THE BRIDGES - PHASE 1

PRELIMINARY CONSTRUCTION DOCUMENTS EDEN, WEBER COUNTY, UTAH

THE BRIDGES - PHASE 1
PRELIMINARY CONSTRUCTION DOCUMENTS

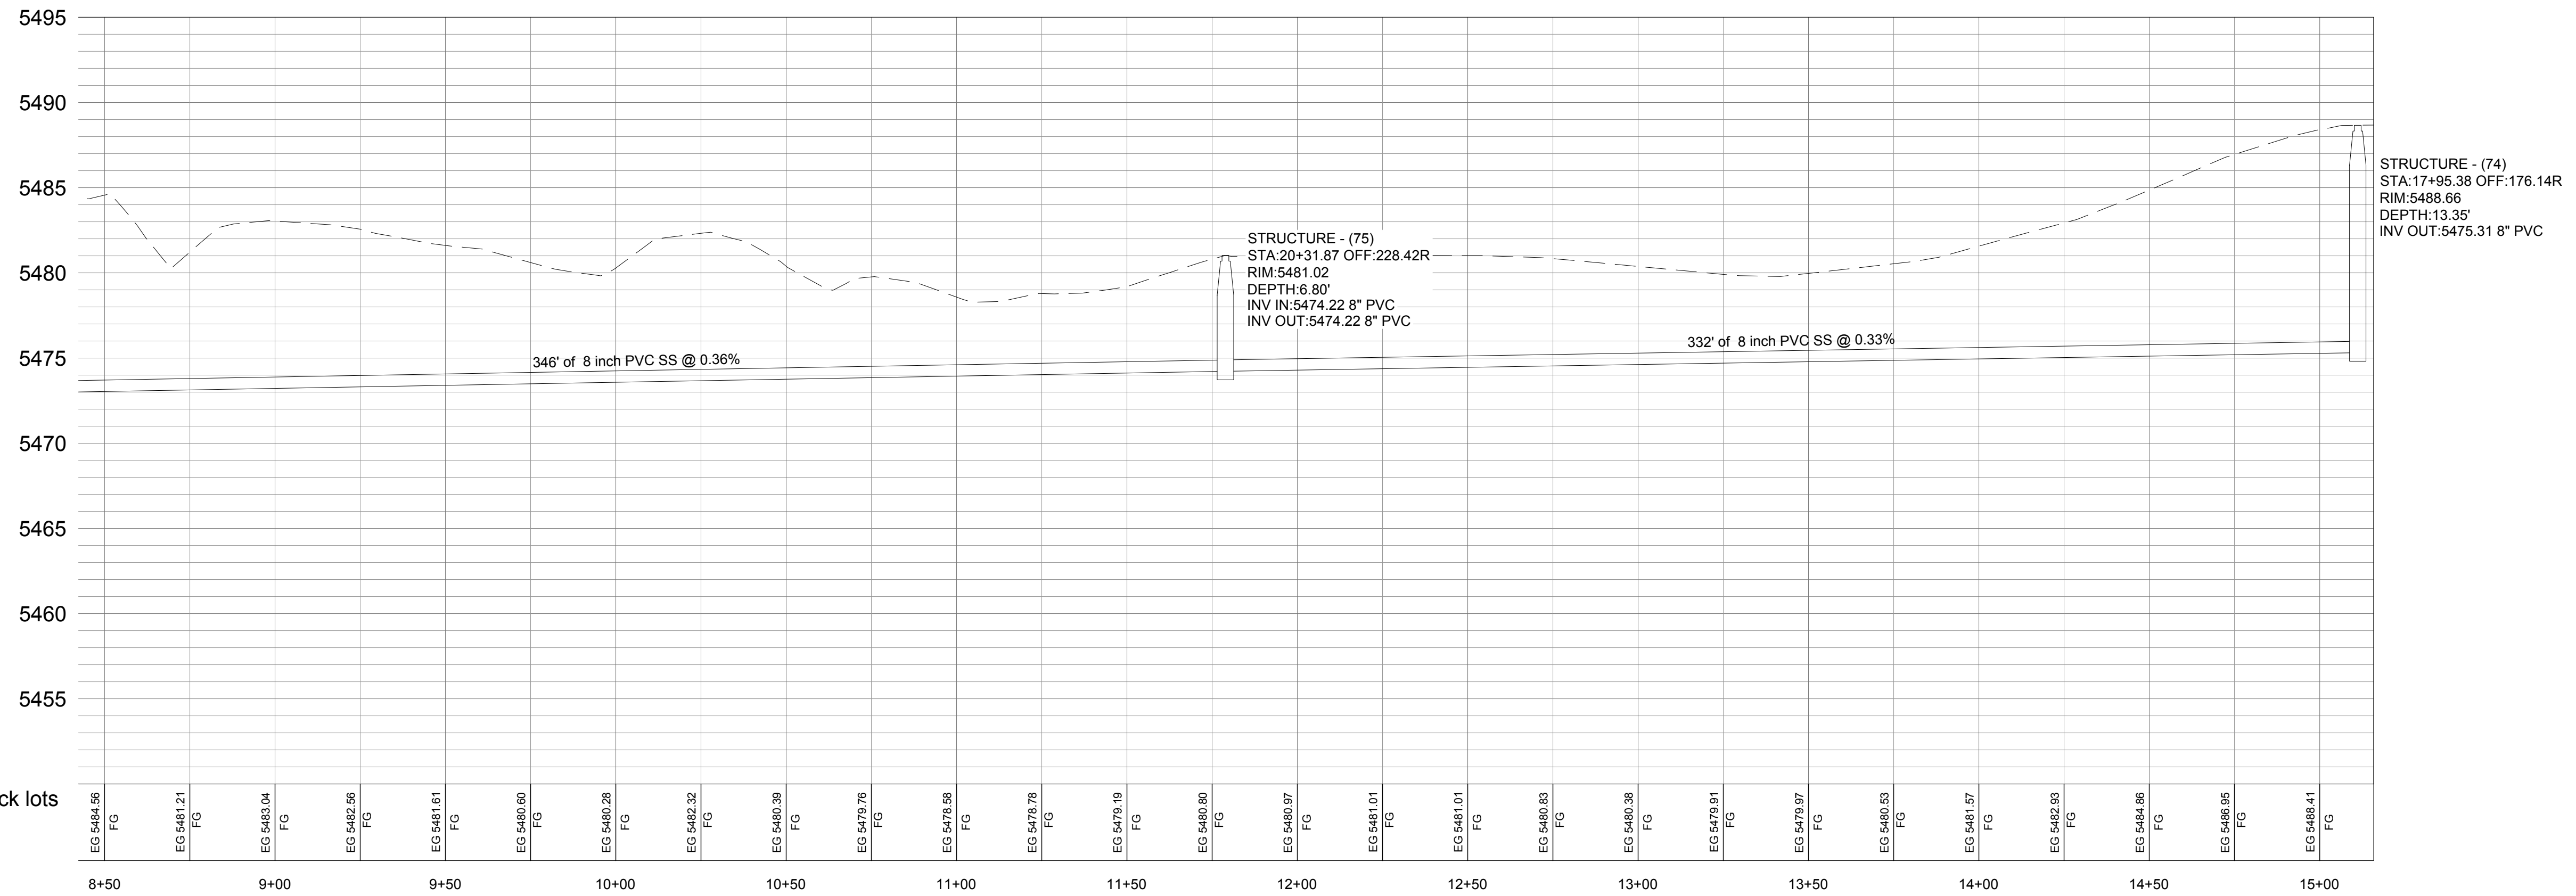
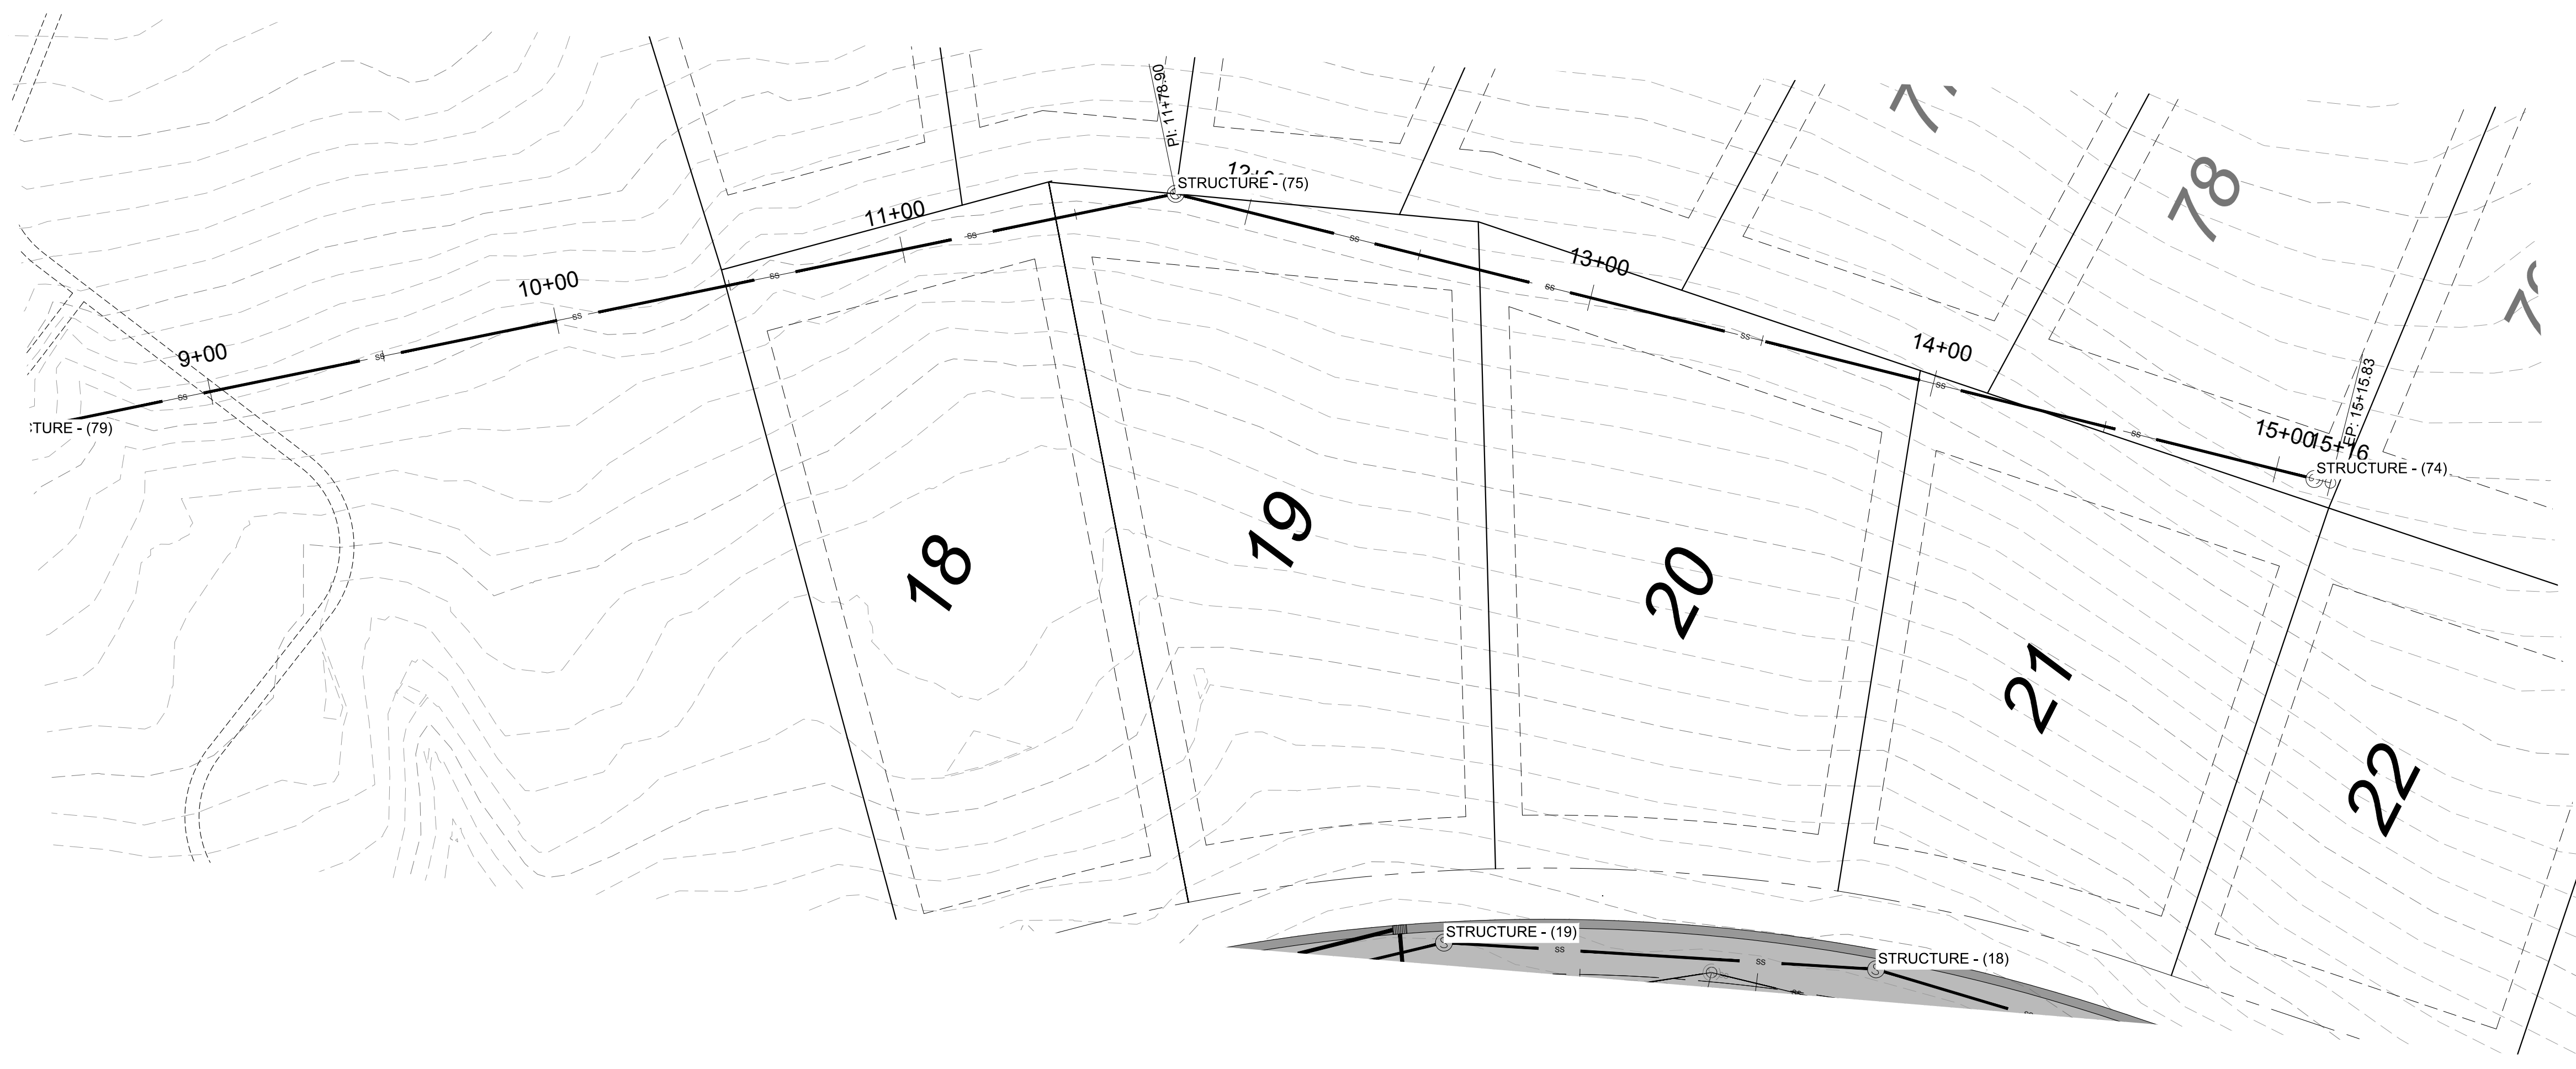
re SEWER back lots

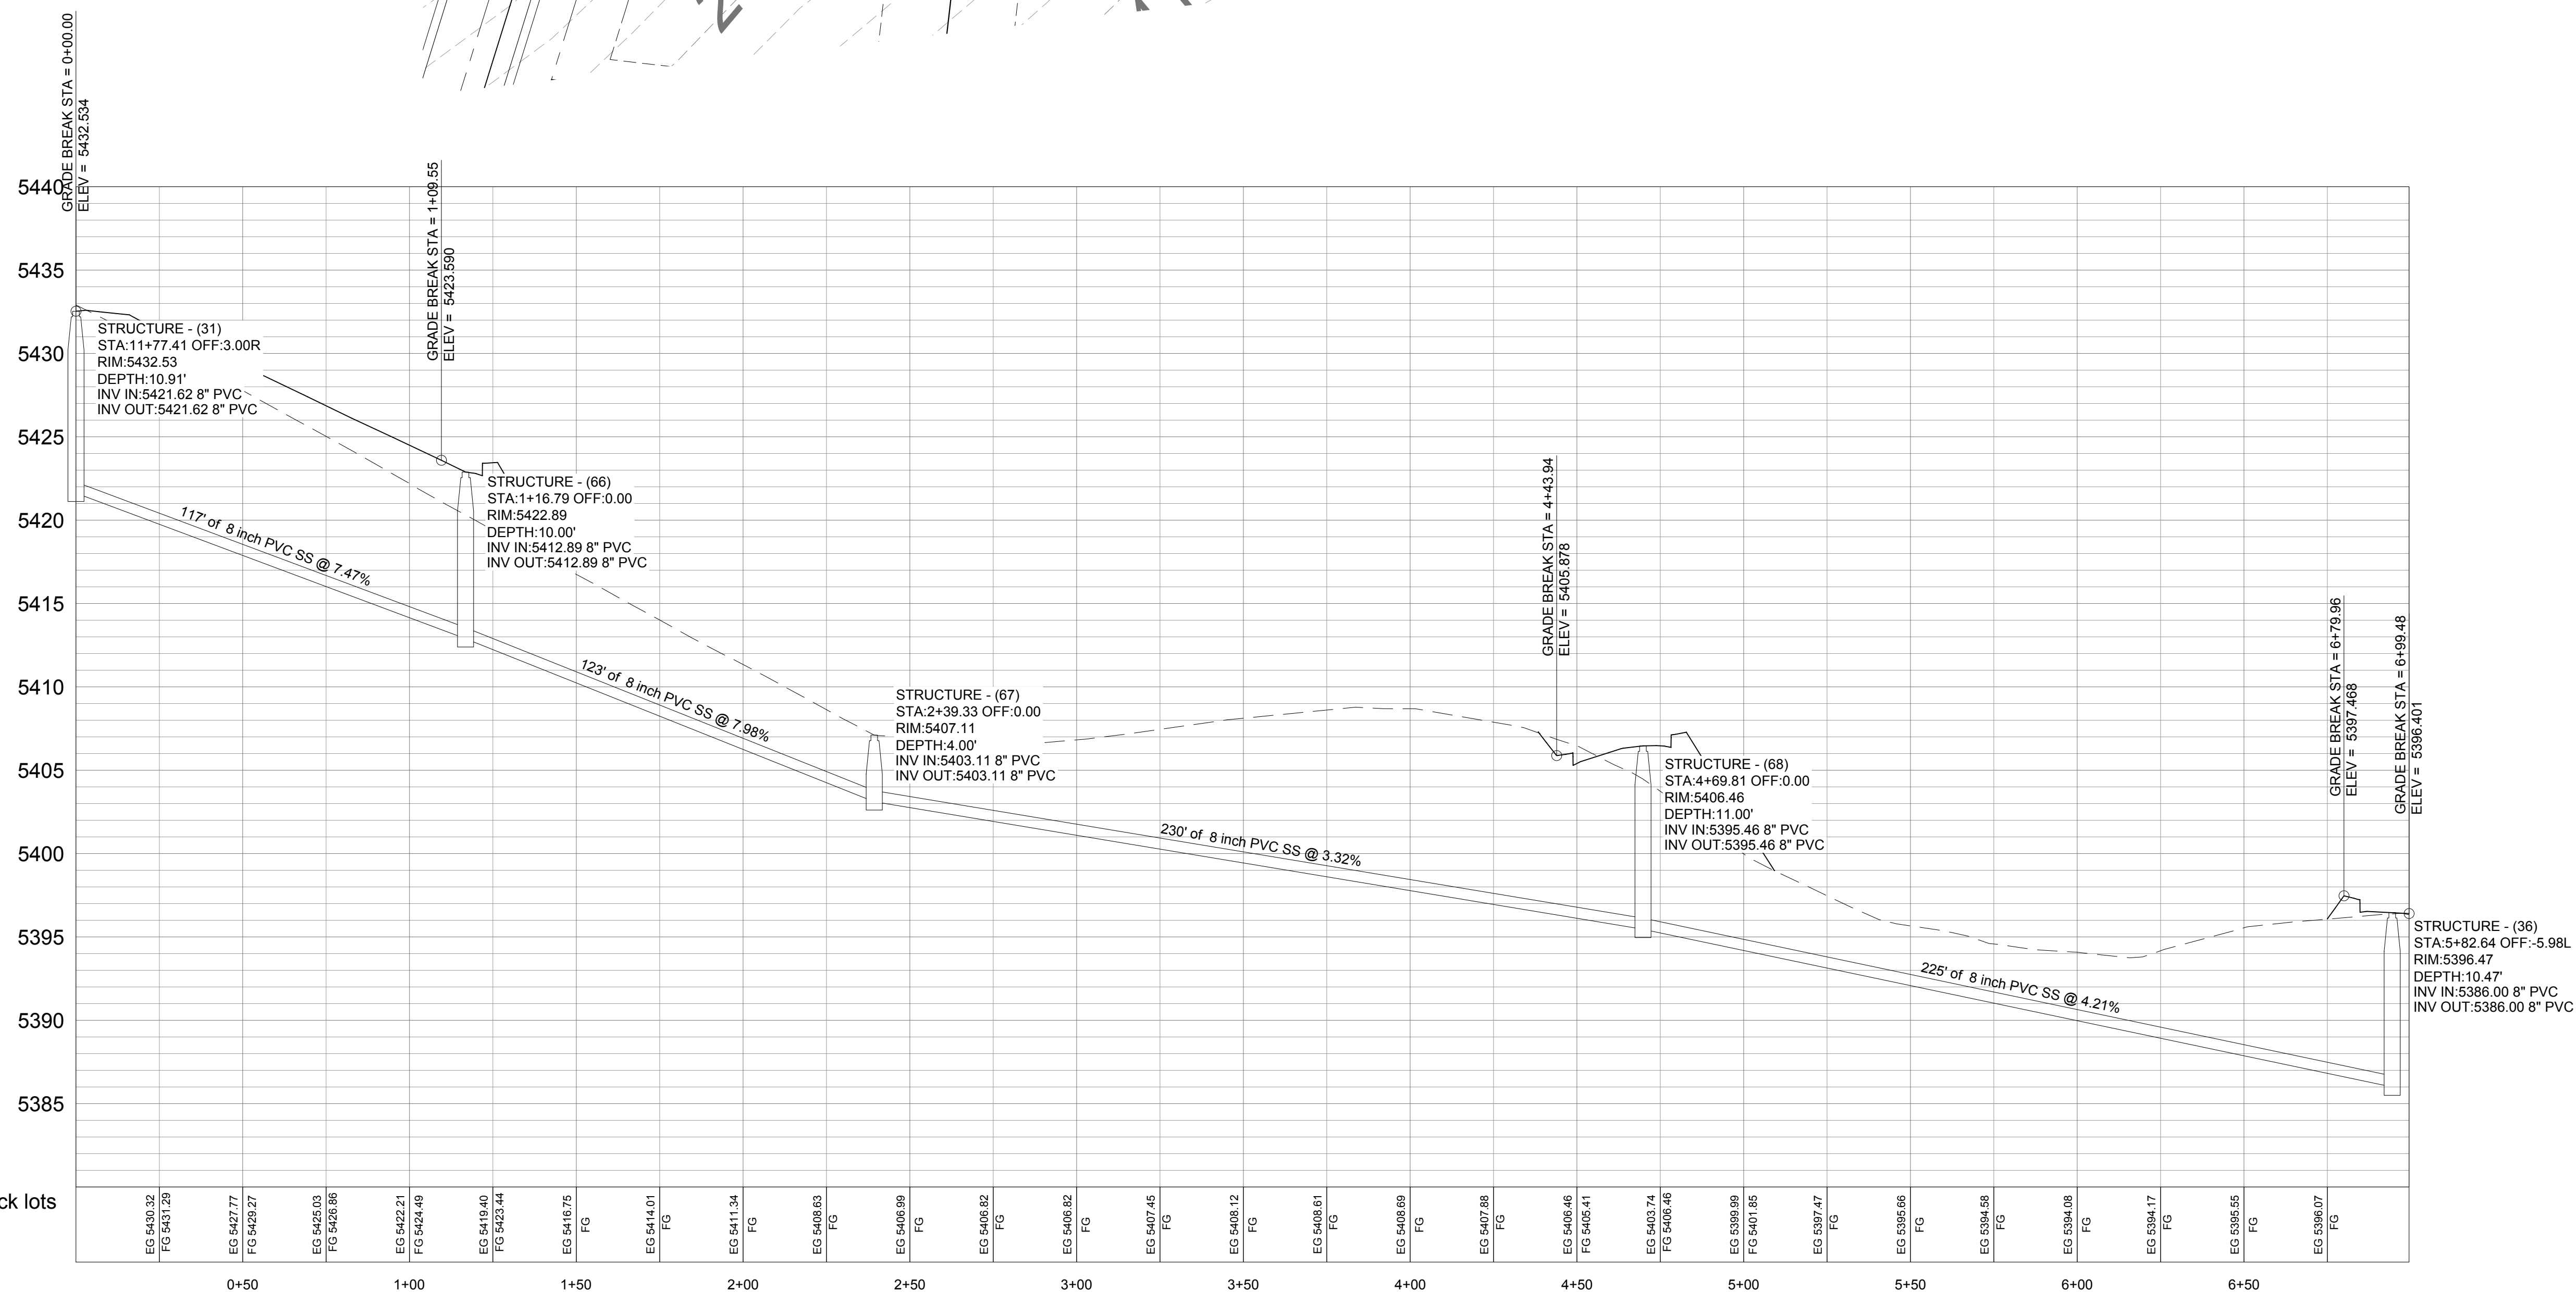
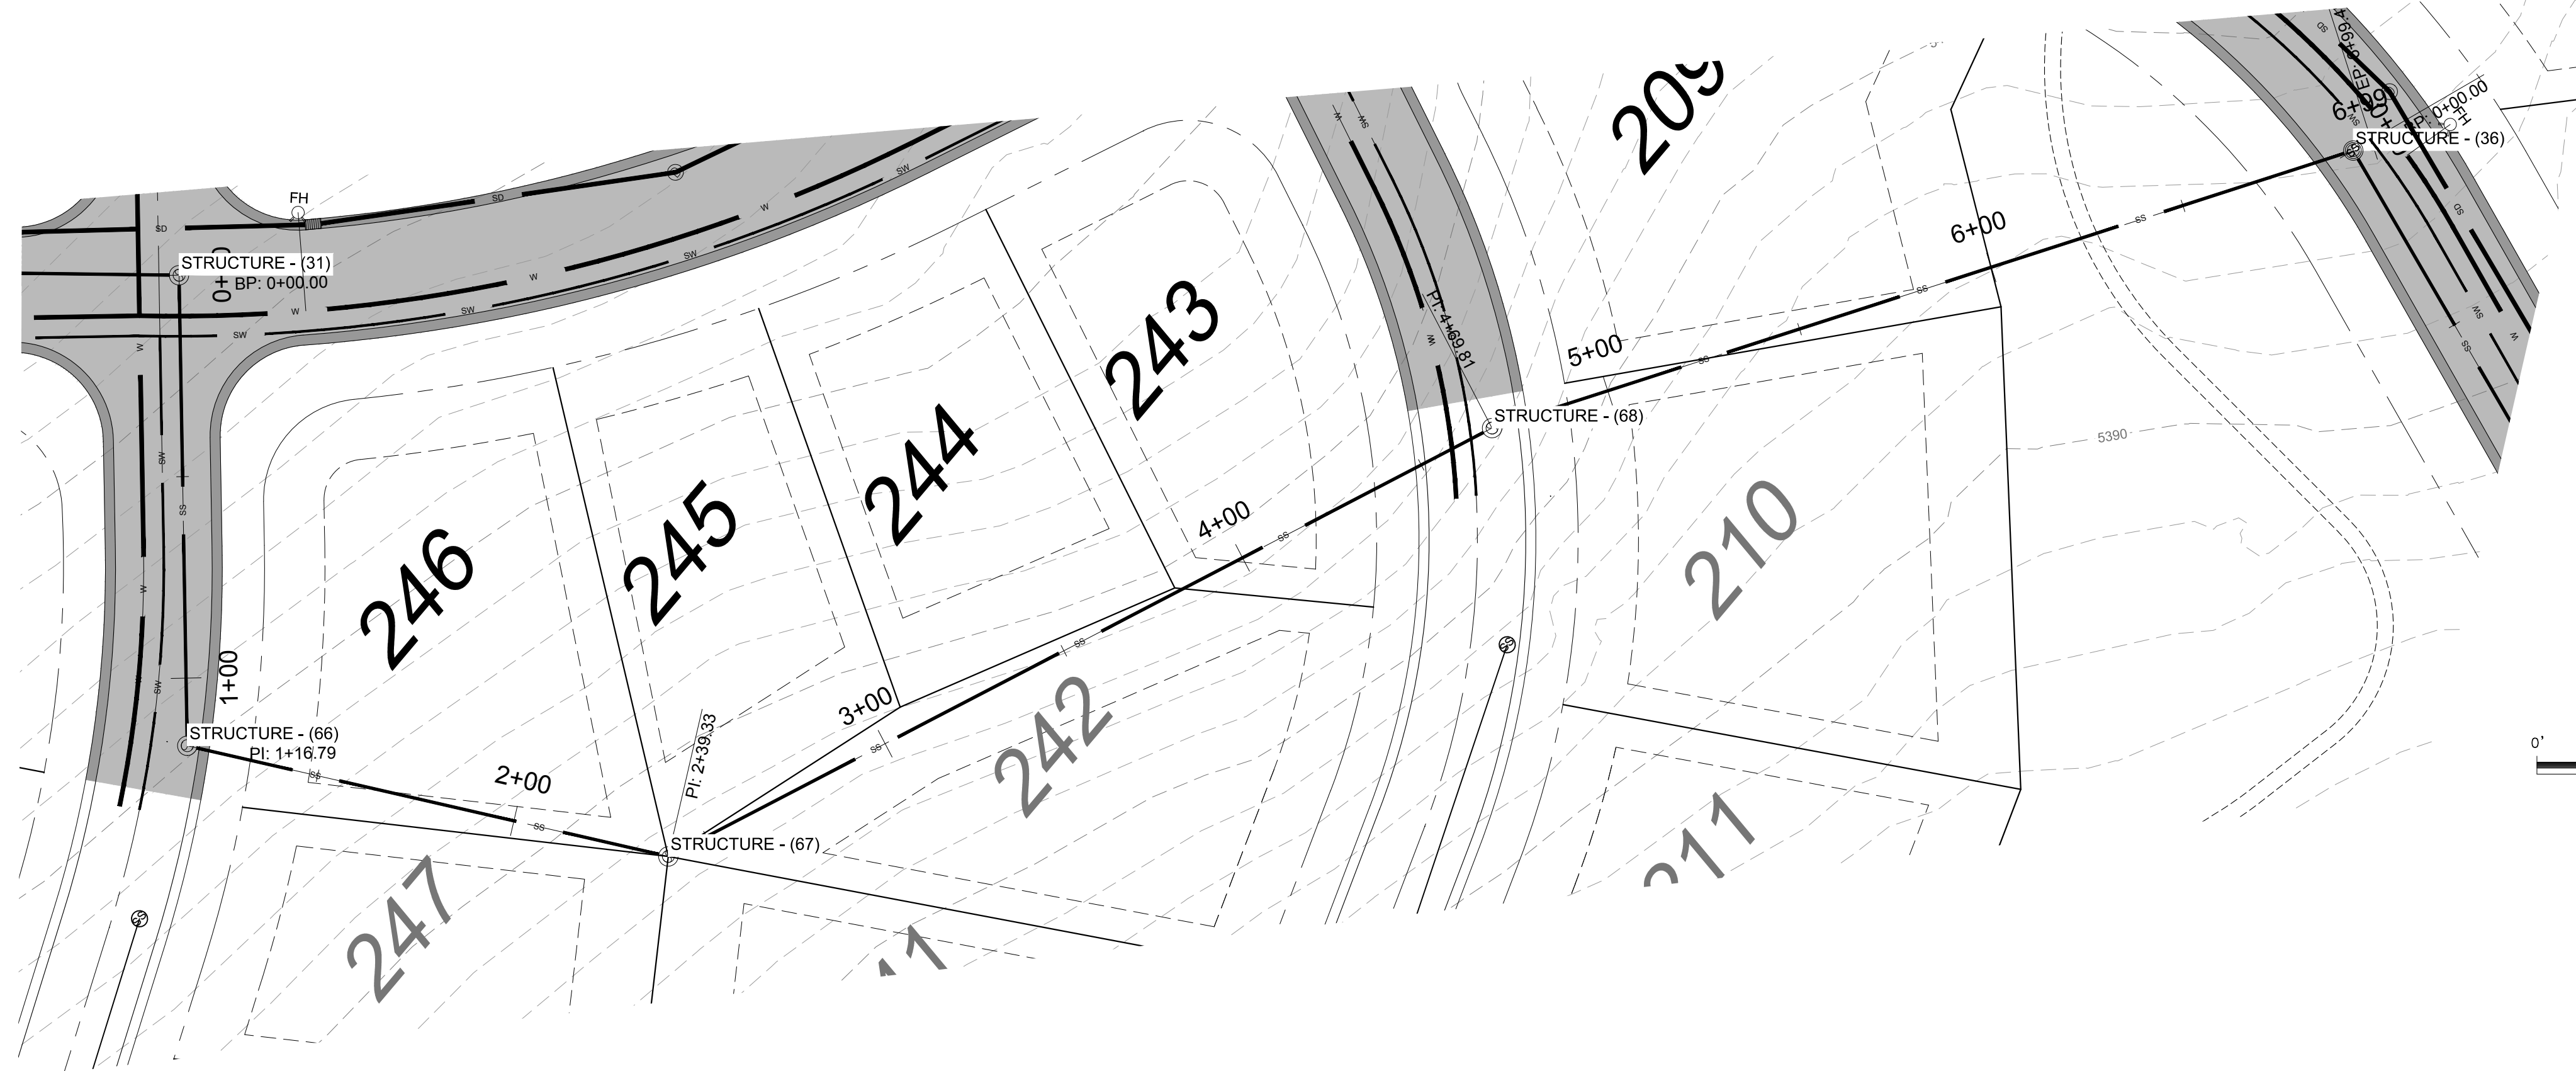
PROPOSED SEWER back lots
